Change Notification CN43-2020

Packing specification change for AS3412-EWLT

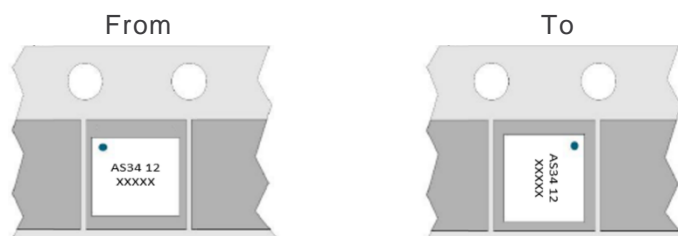
ams has to update pin orientation of AS3412-EWLT, part number 191150045 on carrier, wherein Pin 1 of the device is located from upper left moving to upper right position in reference to internal specification and figure 3 (1 of 2) of EIA-481 standard.

Reason for change: Standardize the pin 1 orientation from upper left to upper right position near the round sprocket holes.

Timing of change: Effective immediately starting Date Code 1908 and onwards.

Impact on Product : No impact on the product as there will be no change in terms of form, fit, function, and reliability of the devices. Customer is advised to assess their set-up.
